33621A-03

# Modification Recommended Service Note

# 33621A Function Generator

Serial Numbers: MY0000000 to MY53700482

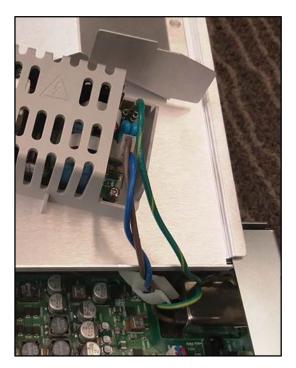
Connect Power Supply Cable (5041-5251) to the Power Supply and the PCB Main Board Assembly.

Re-attach the line power connectors, being careful to get the orientation of the connectors correct.
